SUFFOLK DOWNS REDEVELOPMENT

Supplemental Information Document

MAY 1, 2019

SUBMITTED TO
Boston Planning &
Development Agency

Conceptual Roadway Cross Sections with Utilidor

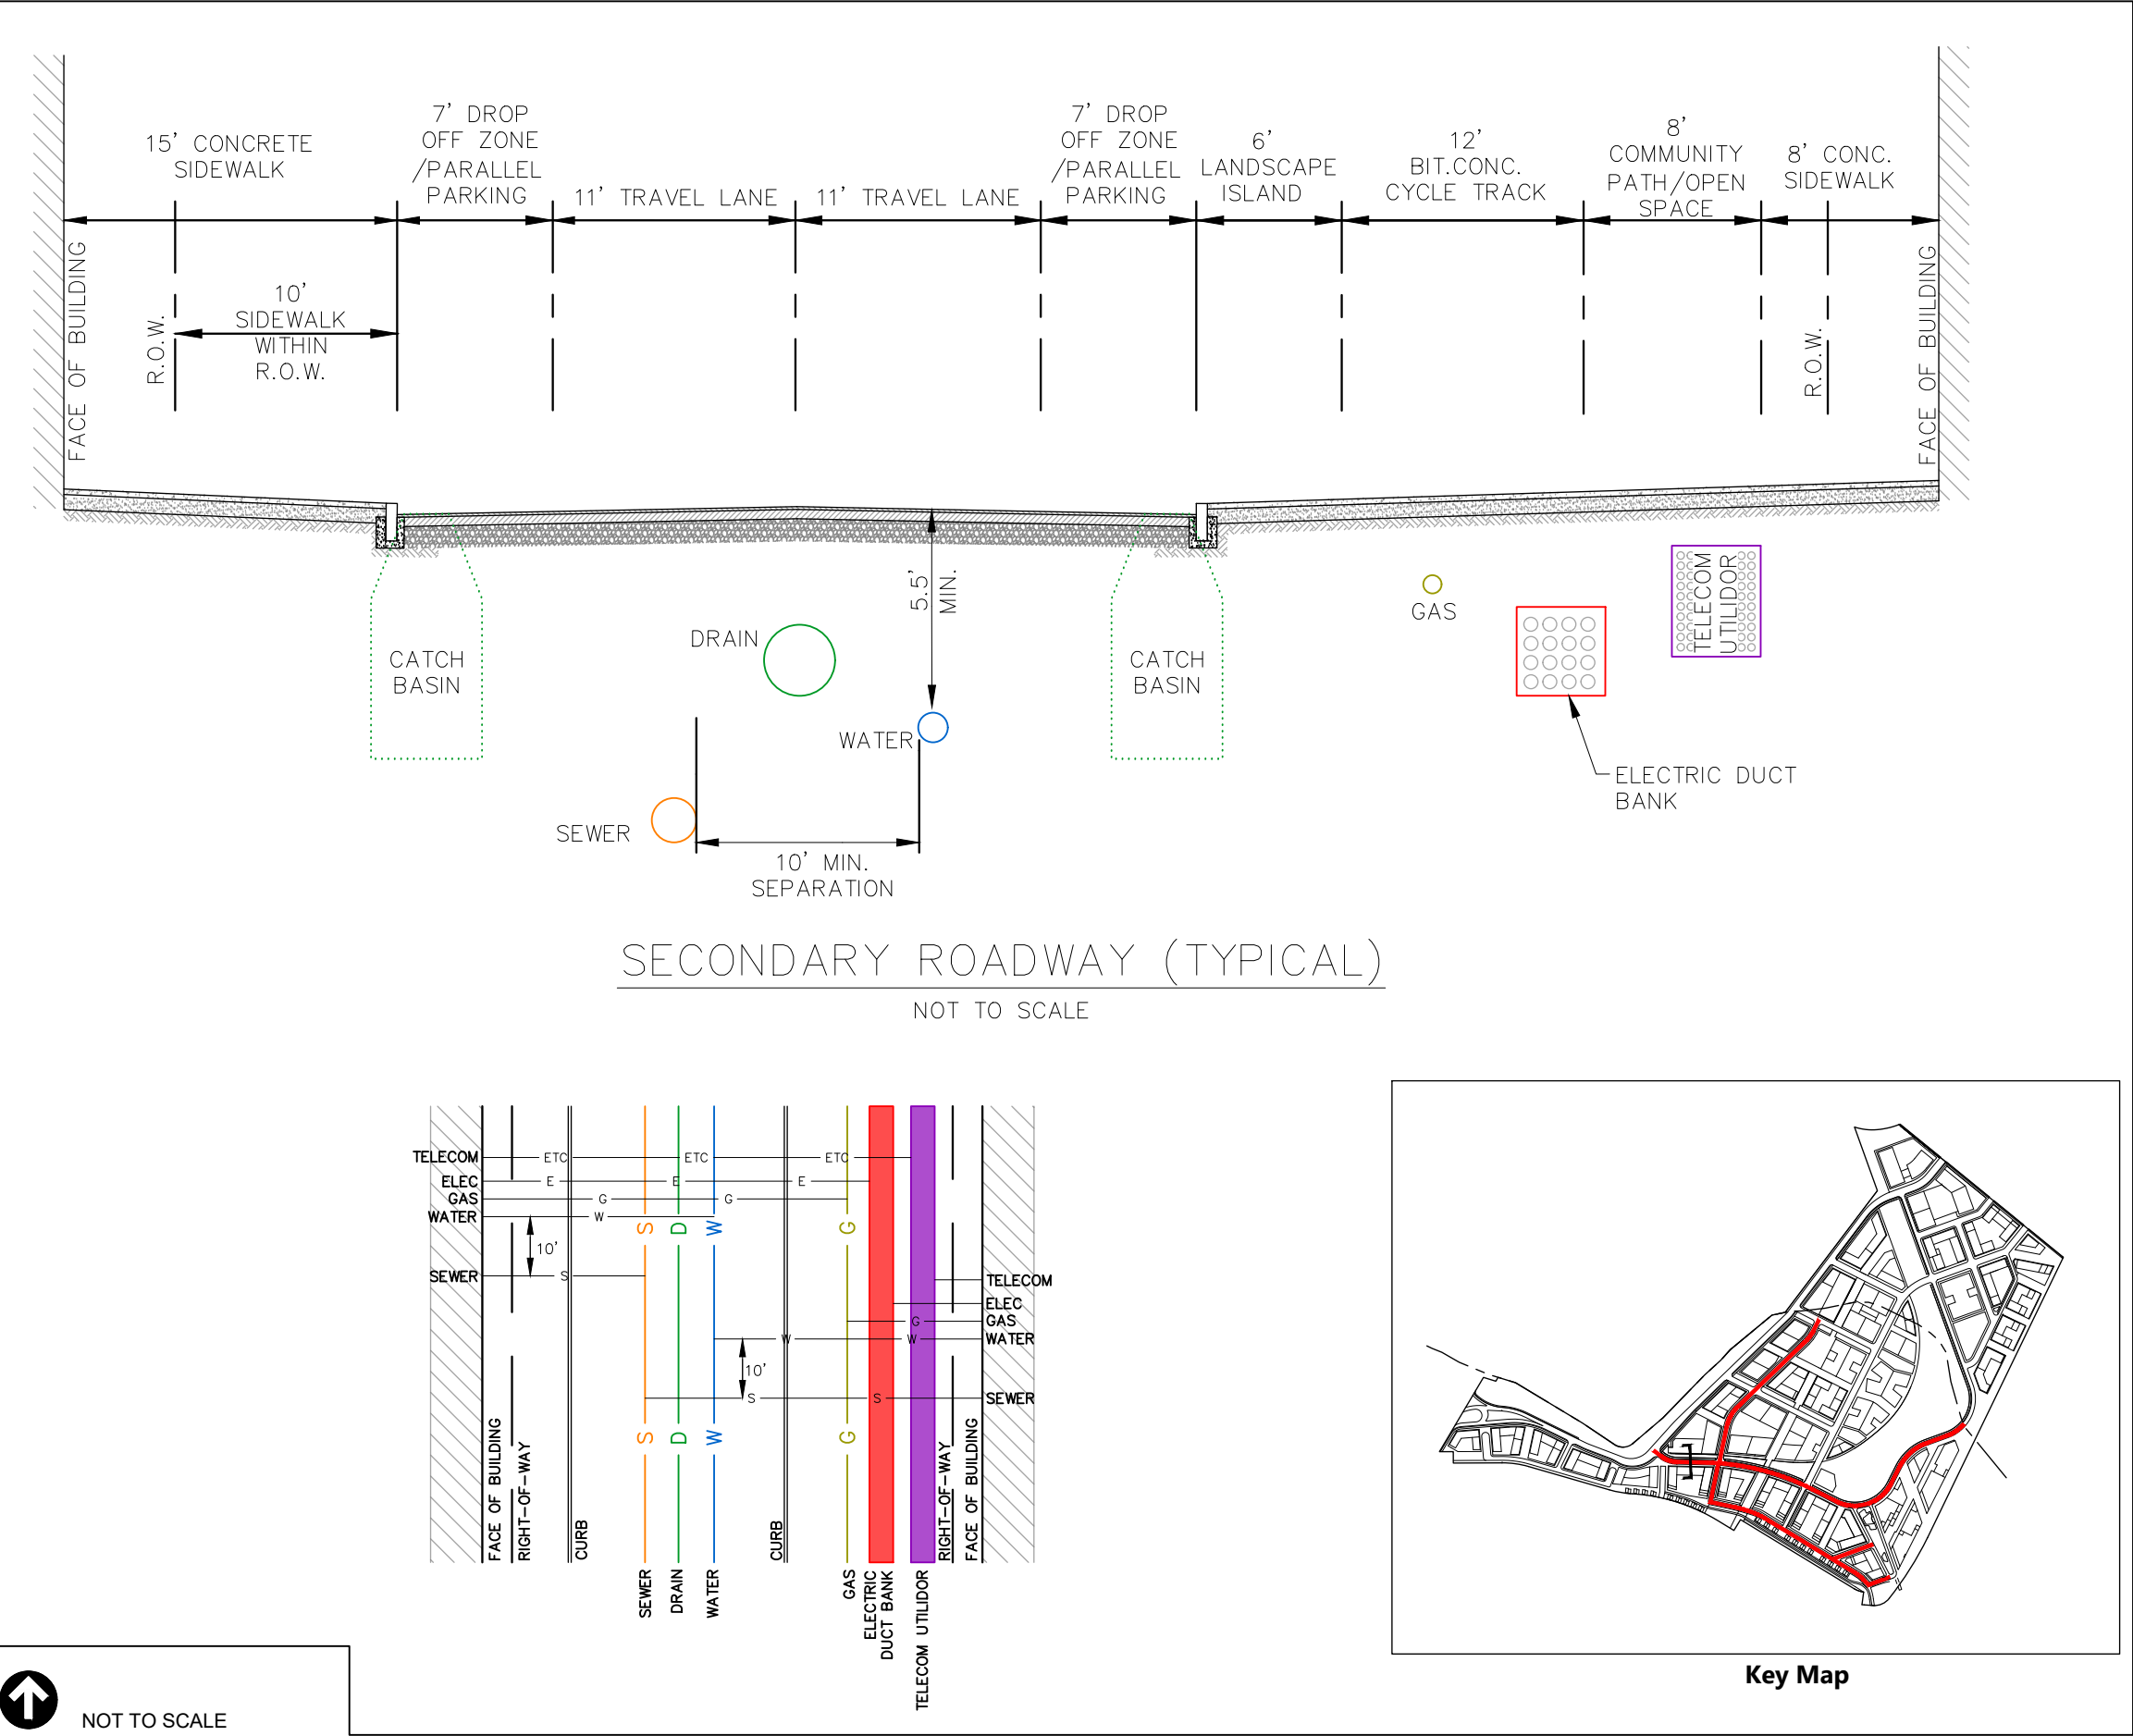
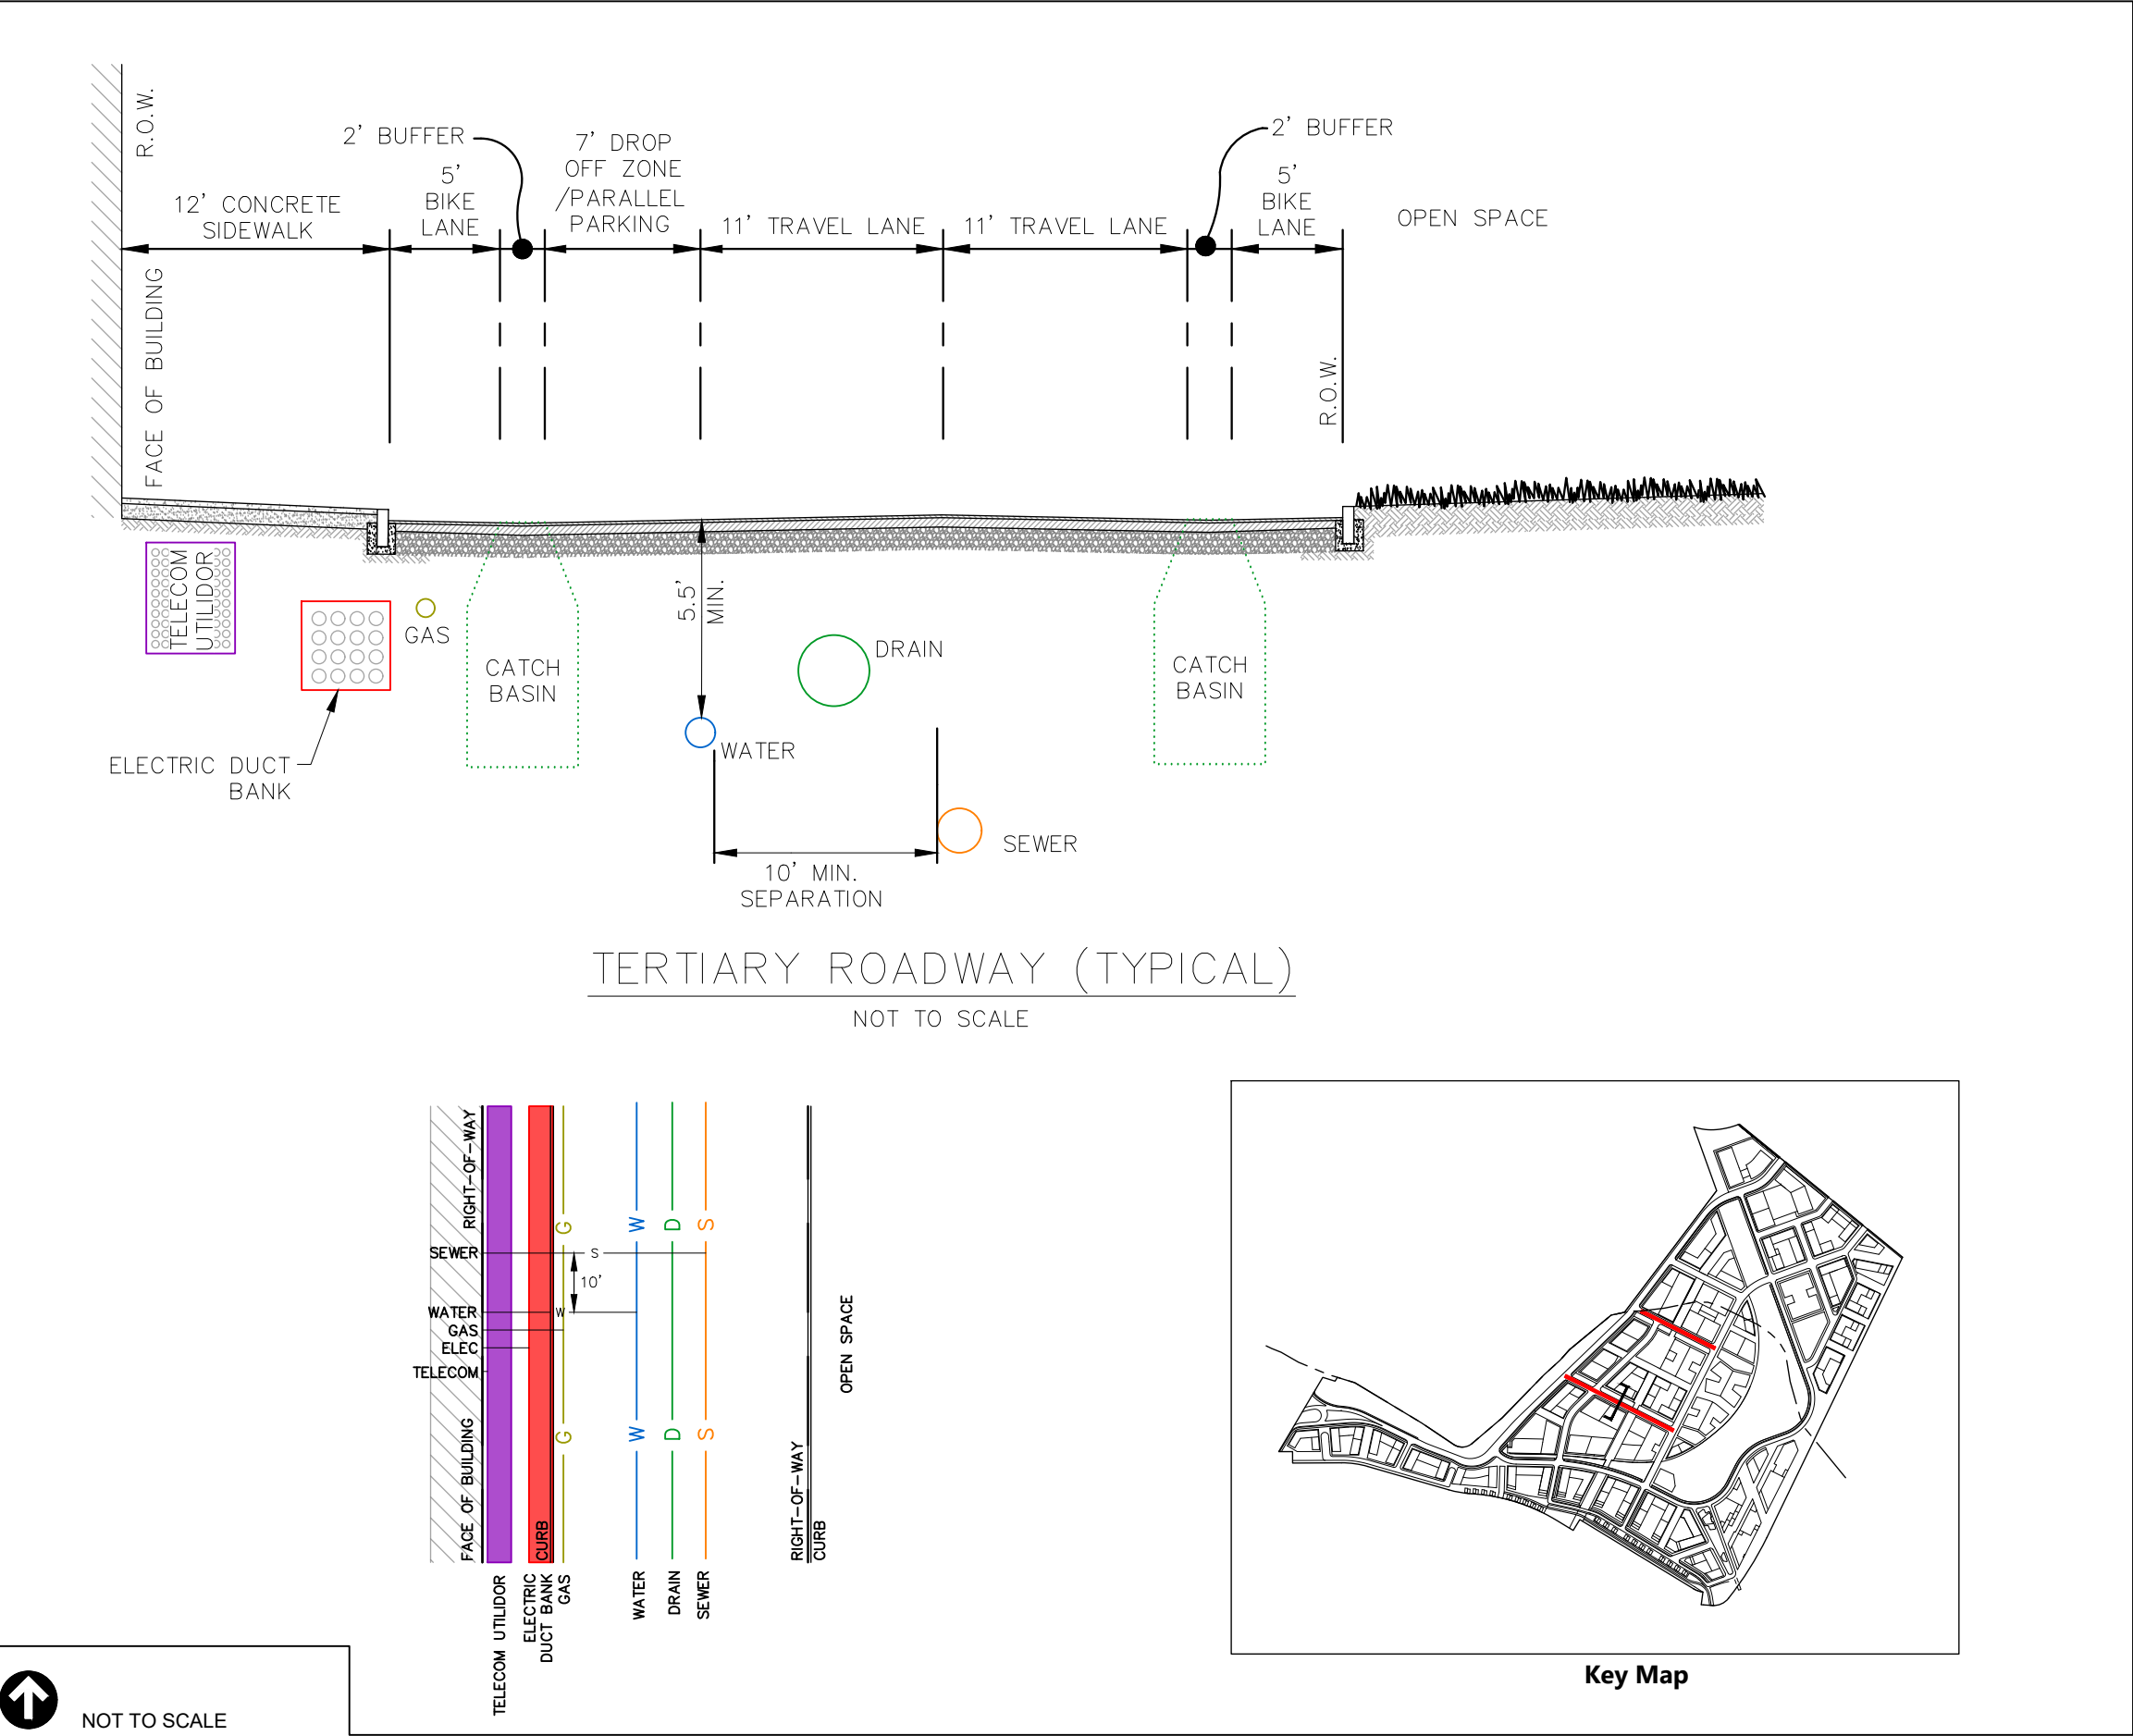
Please refer to Figure 2.7a-c illustrating the conceptual layout and cross-sections of the Telecom Utilidor. It is anticipated that manholes will be spaced a maximum of 300-feet apart with additional access points located at proposed intersections.

Figure 2.10
Open Space Calculations - Active, Passive, and Civic

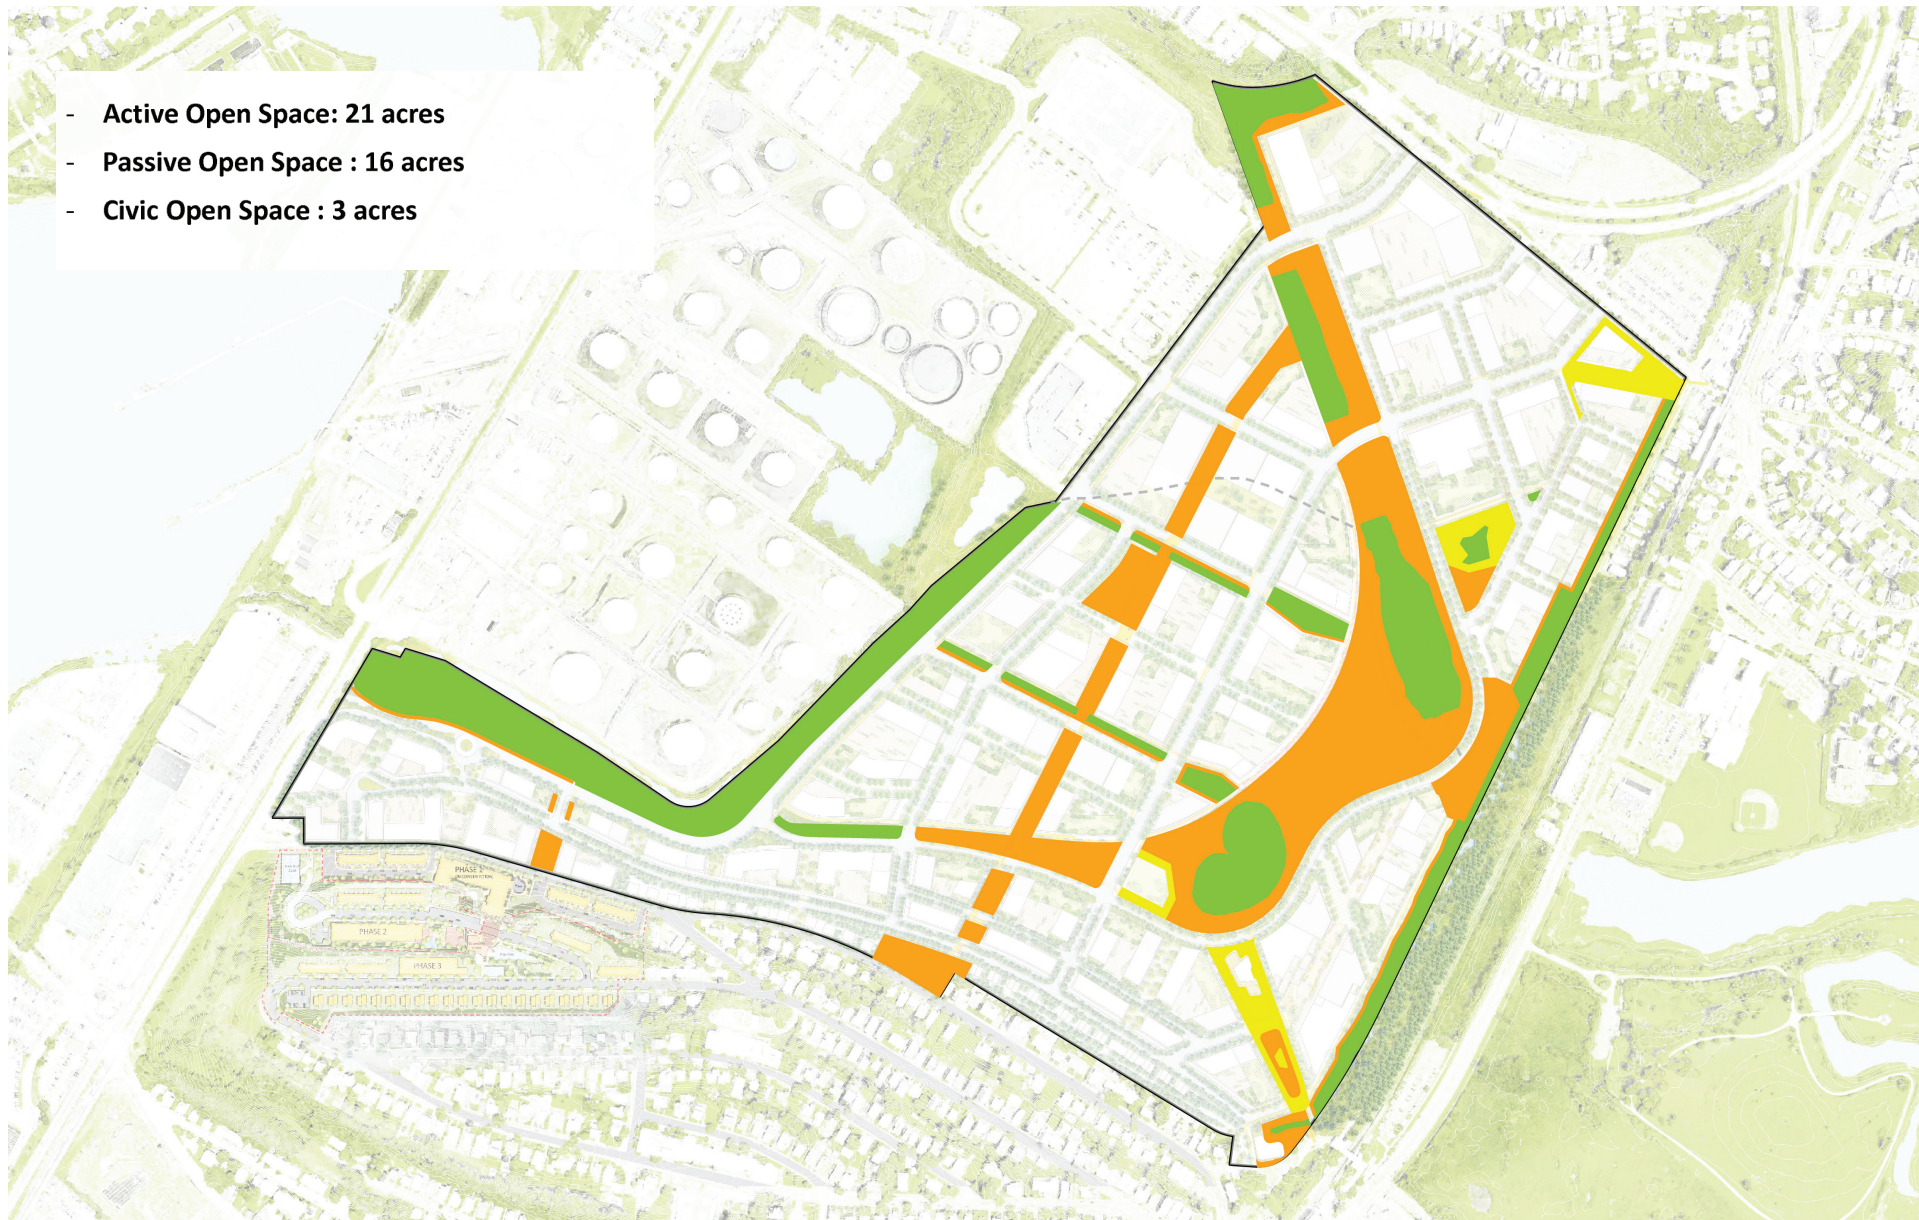
Figure 2.10 (plan of active, passive, and civic) breaks down open space area by type, showing 22 acres of active recreation which will serve the 15,720 new residents at the site (ratio of 1.34 acres / 1,000 people). Figure F in the PDA Master Plan demonstrates how the open space is being calculated. The draft PDA Documents are accessible via the web links provided in Appendix A.
